ADDENDUM NO. 1

PROJECT: Hell Creek State Park Infrastructure Upgrades

FWP PROJECT #: 7176101 DATE: July11, 2018

P-1 rev

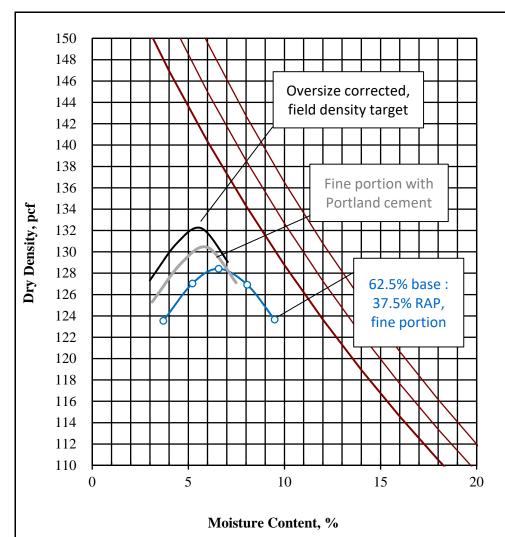
- B. 3. The CTB Mix Design completed by SK Geotechnical is included in the Appendix
- 1. Replace the Proctor P-1 (page 252) with the attached Proctor P-1 rev. For the CTB design use a maximum dry density of 132.2 pcf and 5.7% moisture.
